P.P.D (Regularization NO : 144  
L.O 2017) 2020

VIDE LETTER NO : Reg.L /2654/ 2020  
DATE : /03/ 2020

IN-PRINCIPLE APPROVAL OF LAYOUT FRAMEWORK IN S.NO:234PT, 518PT, 2, 519PT, 520PT & 521PT OF VARADHARAJAPURAM VILLAGE, KUNDRATHUR PANCHAYAT UNION AS PER G.O.(Ms) No:78 H&UD UD4 (3) DEPT. DT:04.05.2017 AND G.O.(Ms) No:172 H&UD UD4 (3) DEPT. DT:13.10.2017 AND OFFICE ORDER NO.15/2018 DT: 12.12.2018.

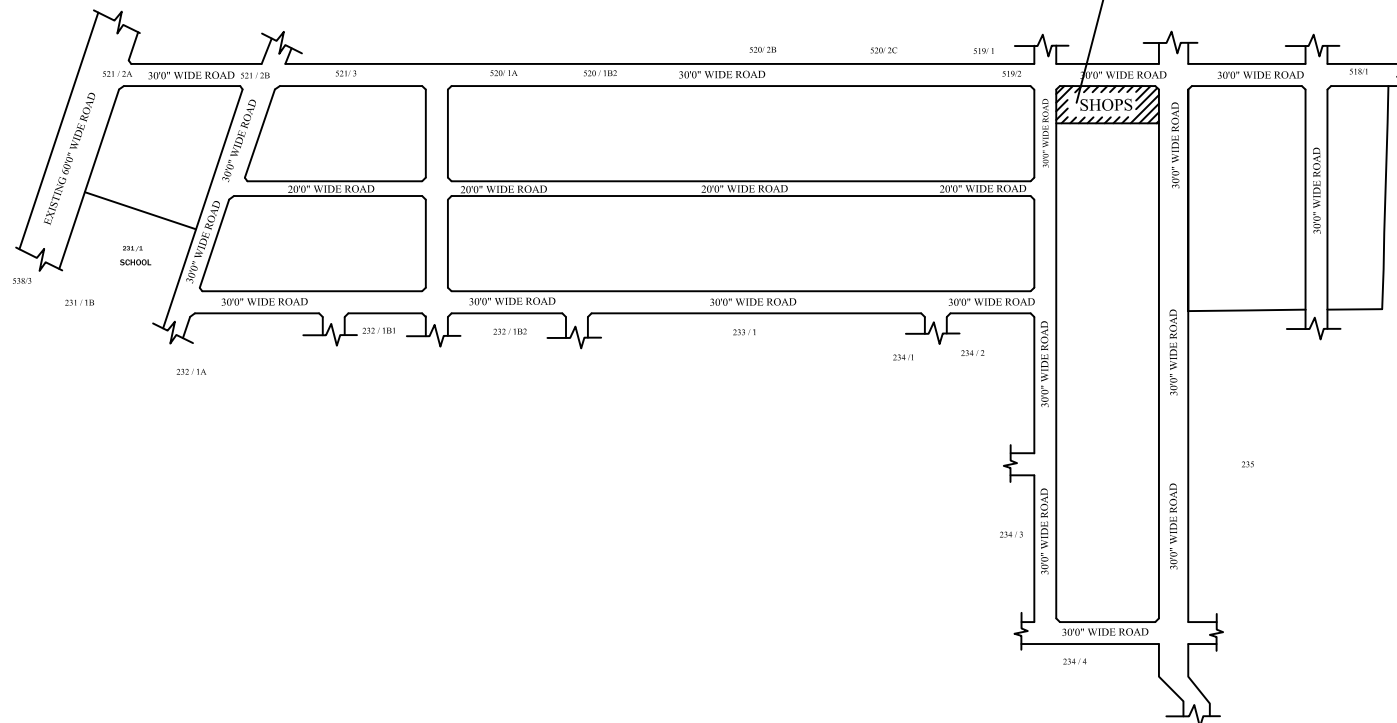
- 1) A SPLAY AT THE INTERSECTION OF TWO OR MORE STREETS / ROADS AND STREET ALIGNMENTS BE PROVIDED AS PER THE DEVELOPMENT REGULATIONS OF CMA.
- 2) KUNDRATHUR PANCHAYAT UNION TO ENSURE THAT ALL THE ROADS ARE VESTED WITH THEM AS PER THE GOVERNMENT ORDERS.

- 10) S.No.518 of Varadharajapuram Village is close to water body, Hence The Local Body has to obtain NOC from PWD on inundation point of view and NOC from Tahsildar concerned to be obtained that, the layout is not obstructing the water ways on the common fields irrigation on the ground, before regularization of individual plots in the layout under the reference.

- 11) The Regularisation of layout site was inspected by Kundrathur Panchayat Union and forwarded to CMDA with recommendation to accord framework approval. As per the master plan the site under reference lies contiguous to water body as a agricultural landuse. Hence Kundrathur Panchayat Union should ensure the layout is not part of water body before regularising the individual plot in layout.

THIS PORTION NOT IS INCLUDED IN FRAMEWORK APPROVAL UNDER THIS SCHEME
